SUBDIVISION REPORT - CONCEPT/USE ON REVIEW

▶ **FILE #:** 7-SC-20-C **AGENDA ITEM #:** 22
7-C-20-UR **AGENDA DATE:** 8/13/2020

▶ **SUBDIVISION:** SMITH DEVELOPMENT - GOVERNOR JOHN SEVIER HWY.

▶ **PROPOSED USE:** Detached residential subdivision

CONCEPT/DEVELOPMENT PLAN FOR
 SMITH DEVELOPMENT - GOV. JOHN SEVER HIGHWAY
 TAX MAP 148, PARCELS 1 & 1.01
 DISTRICT 9, KNOX COUNTY, TENNESSEE

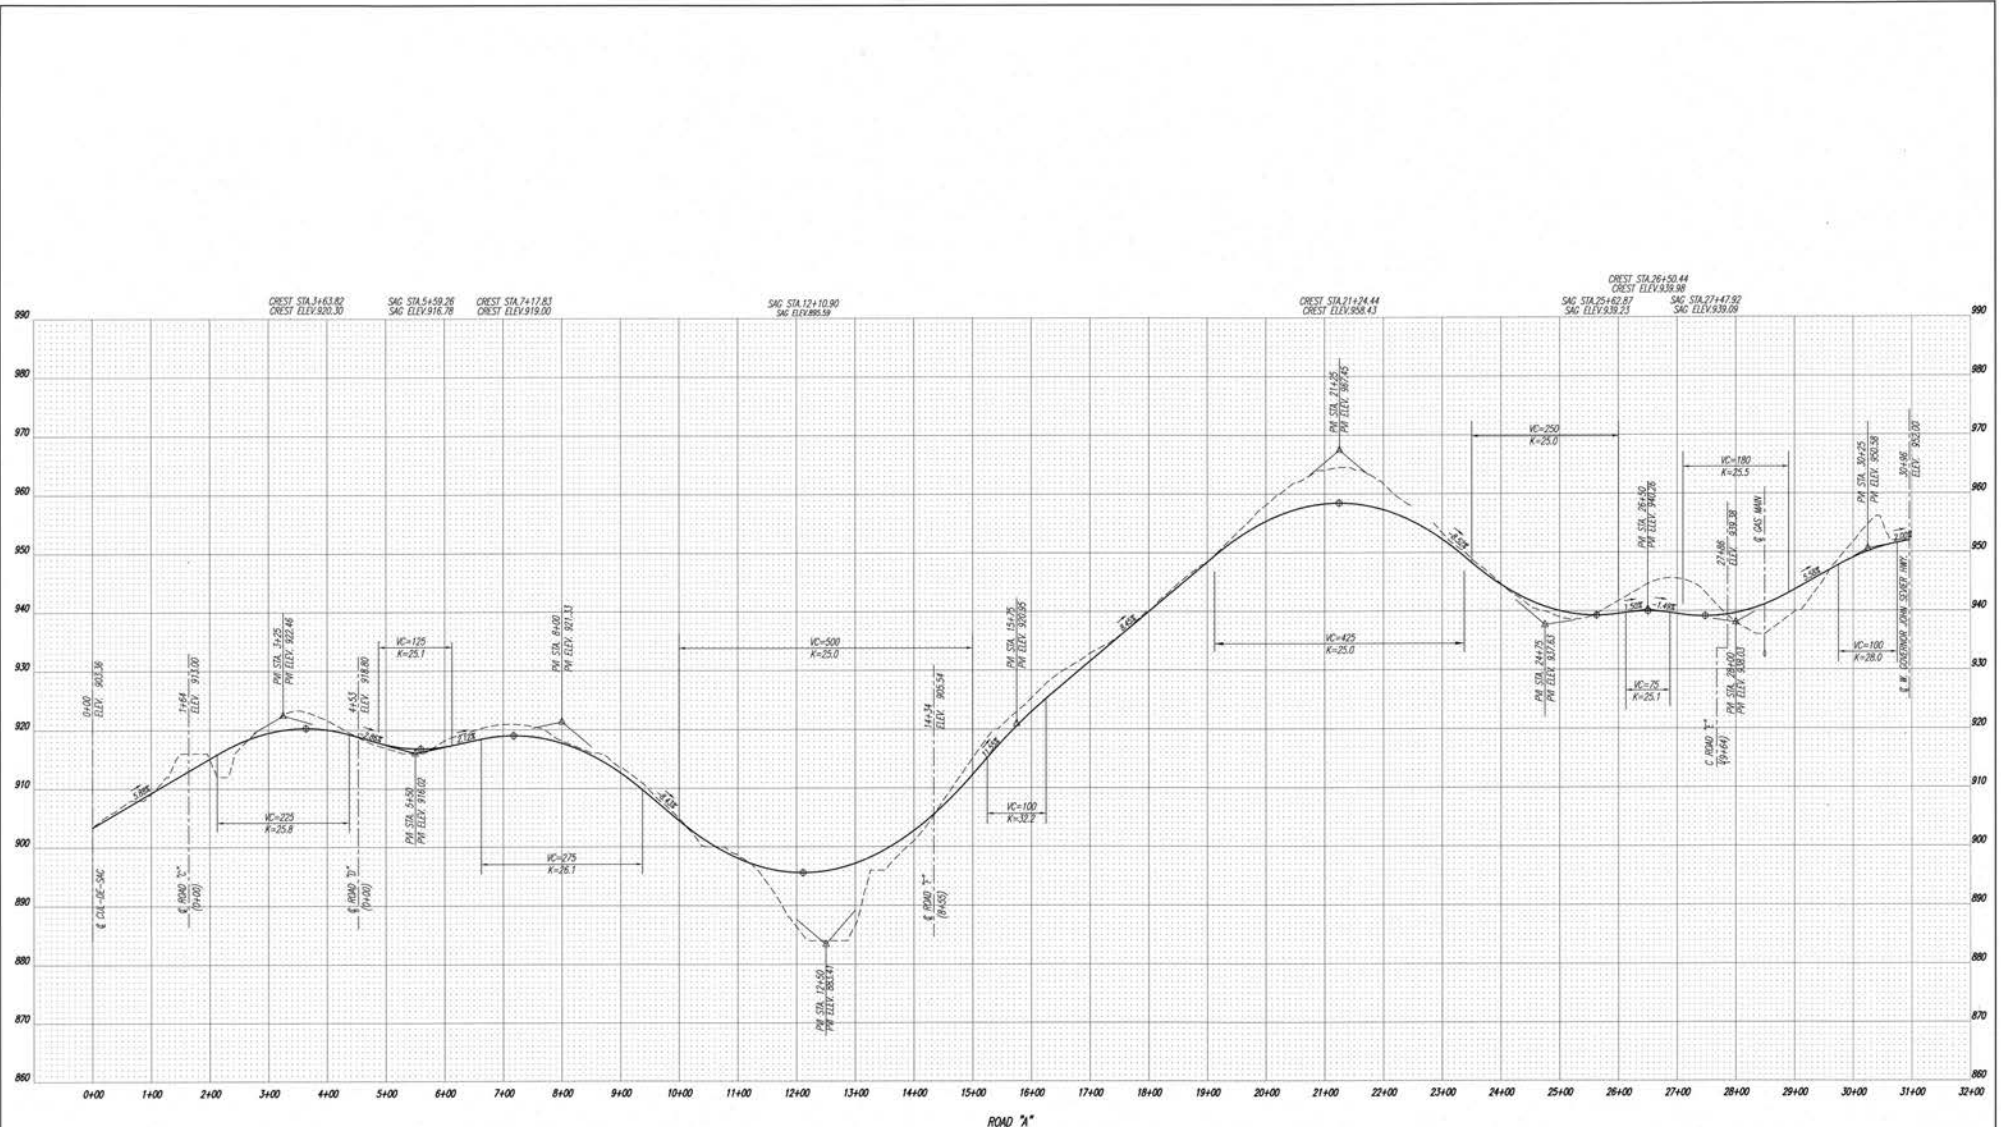
- 1) Reduction of horizontal curve radius on Road 'A' from 250 feet to 125' feet at STA 7+50.
- 2) Reduction of horizontal curve radius on Road 'A' from 250 feet to 175' feet at STA 19+50.
- 3) Reduction of horizontal curve radius on Road 'A' from 250 feet to 175' feet at STA 28+75.

- 1) Intersection grades between 1 and 3 percent for all approaches to an intersection.
- 2) Reduction of the Governor John Sevier Highway right-of-way dedication from 56' to 50'.

- 6) Providing a 200' sight distance easement along the Road 'A' frontage of Lot 89 as identified on the Concept Plan.
 - 7) Providing documentation of an approved waiver from the Tennessee Department of Transportation (TDOT) during design plan review for the requested reduction of right-of-way dedication from 56' to 50' from the centerline of Governor John Sevier Highway. If TDOT does not approve the waiver, the right-of-way requirements of the Major Road Plan must be dedicated.

- 2) Providing a tree buffer with 50' of depth along the Governor John Sevier Highway frontage this is within common area, as shown on the development plan.

- **APPROVE** alternate design standard 1-3 based on the recommendations of the Knox County Department of Engineering and Public Works.

APPROVE the Concept Plan subject to 8 conditions.

TABLE 6
2025 INTERSECTION CAPACITY ANALYSIS RESULTS -
WEST GOVERNOR JOHN SEVIER HIGHWAY (SR 168) AT ROAD "A"
OPENING YEAR (WITH PROJECT) AND EB RIGHT TURN LANE

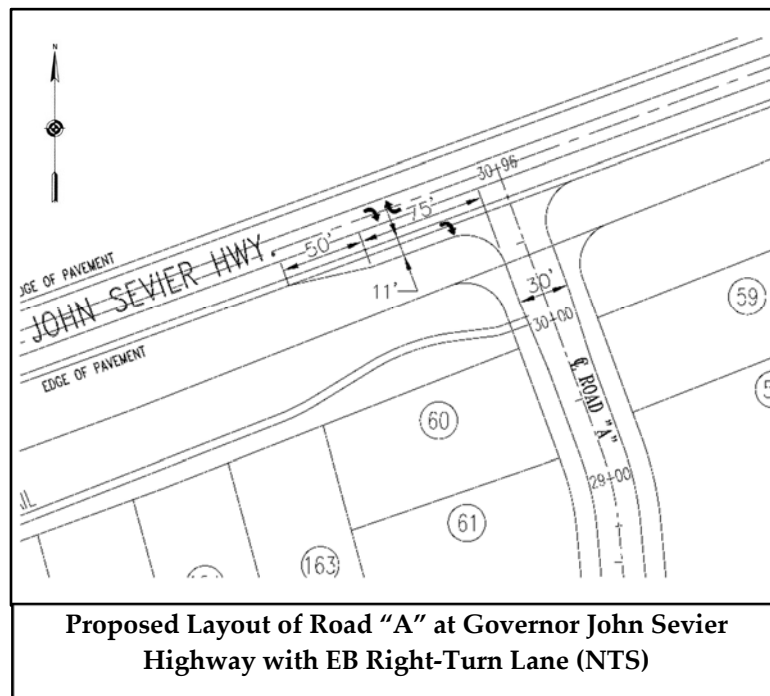
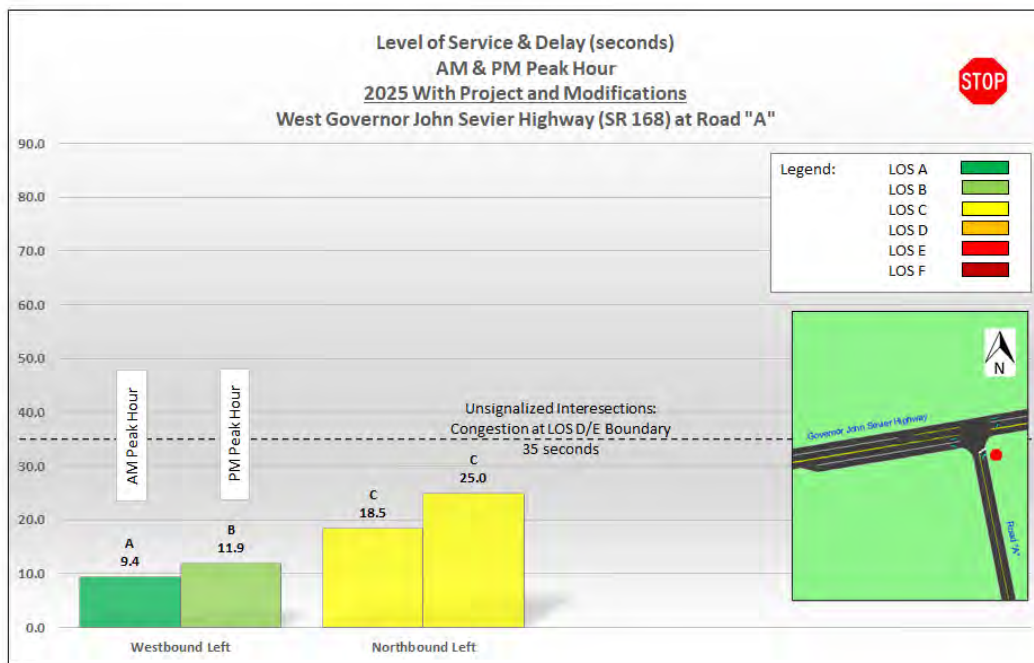
- 1c) As discussed earlier in Potential Safety Issues, Evaluation of Turn Lane Thresholds, the intersection of West Governor John Sevier Highway (SR 168) at Road “A” does not warrant an exclusive eastbound right-turn lane. However, after reviewing this study, the TDOT has recommended that a separate right-turn lane be constructed at Road “A”. Typically, the length of a right-turn lane would be determined by calculating the stopping sight distance based on the observed operating speed. The length recommended in A Policy on Geometric Design of Highway and Streets by AASHTO is calculated to be 480 feet for eastbound vehicles to decelerate and stop from an observed 85th percentile speed of 55.7 mph. However, this recommended length is based on vehicles coming to a complete stop, and the right-turning vehicles coming off West Governor John Sevier Highway (SR 168) onto Road “A” will not completely stop. The civil site designer has proposed for a 75-foot right-turn storage length with a 50-foot taper. A diagram of this layout at Road “A” is provided below. The right-turn lane should be marked with the appropriate right-turn pavement marking symbols. With the recommended right-turn eastbound lane at Road “A”, the capacity analysis was re-calculated, and the results are shown in Table 6.

TABLE 7
 2025 INTERSECTION CAPACITY ANALYSIS RESULTS -
 WEST GOVERNOR JOHN SEVIER HIGHWAY (SR 168) AT ROAD "B"
 OPENING YEAR (WITH PROJECT) AND EB RIGHT TURN LANE

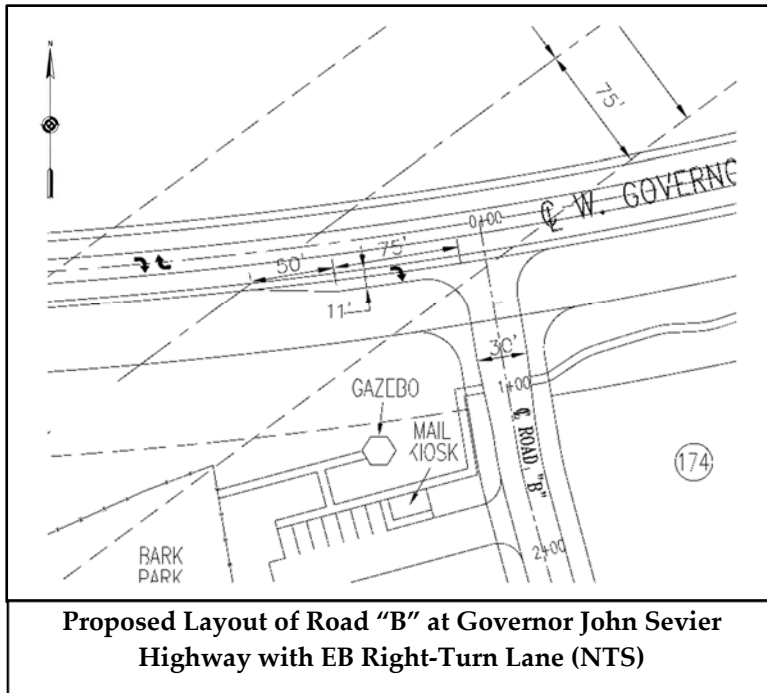
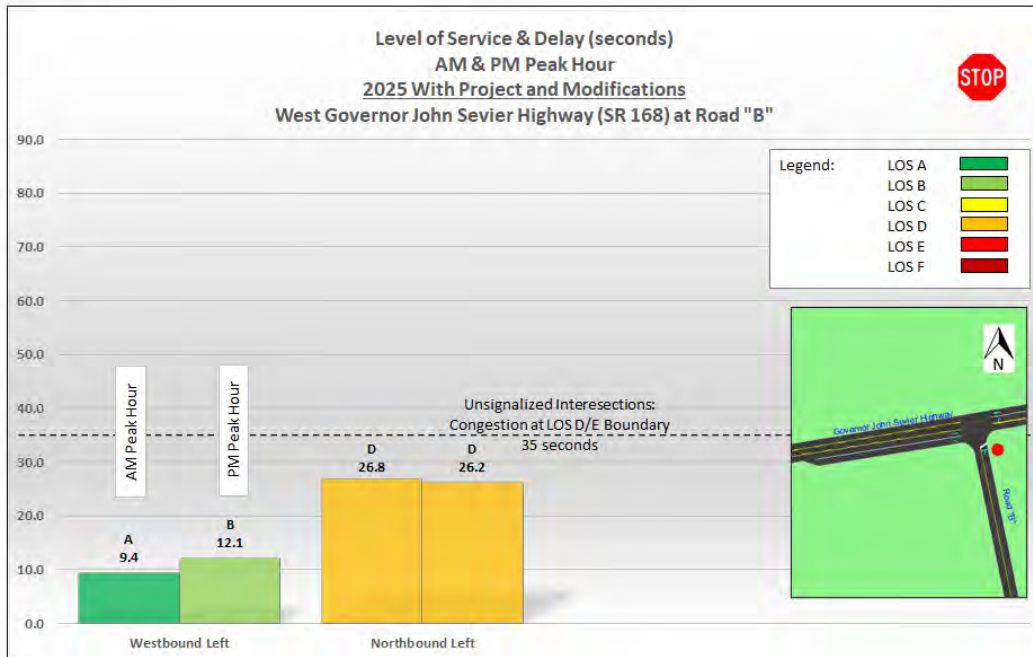
- 2c) As discussed earlier in Potential Safety Issues, Evaluation of Turn Lane Thresholds, the intersection of West Governor John Sevier Highway (SR 168) at Road "B" does warrant an exclusive eastbound right-turn lane. Typically, the length of a right-turn lane would be determined by calculating the stopping sight distance based on the observed operating speed. The length recommended in A Policy on Geometric Design of Highway and Streets by AASHTO is calculated to be 480 feet for eastbound vehicles to decelerate and stop from an observed 85th percentile speed of 55.7 mph. However, this recommended length is based on vehicles coming to a complete stop, and the right-turning vehicles coming off West Governor John Sevier Highway (SR 168) onto Road "B" will not completely stop. The civil site designer has proposed for a 75-foot right-turn storage length with a 50-foot taper. A diagram of this layout at Road "B" is provided below. The right-turn lane should be marked with the appropriate right-turn pavement marking symbols. With the recommended right-turn eastbound lane at Road

“B”, the capacity analysis was re-calculated, and the results are shown in Table 7.
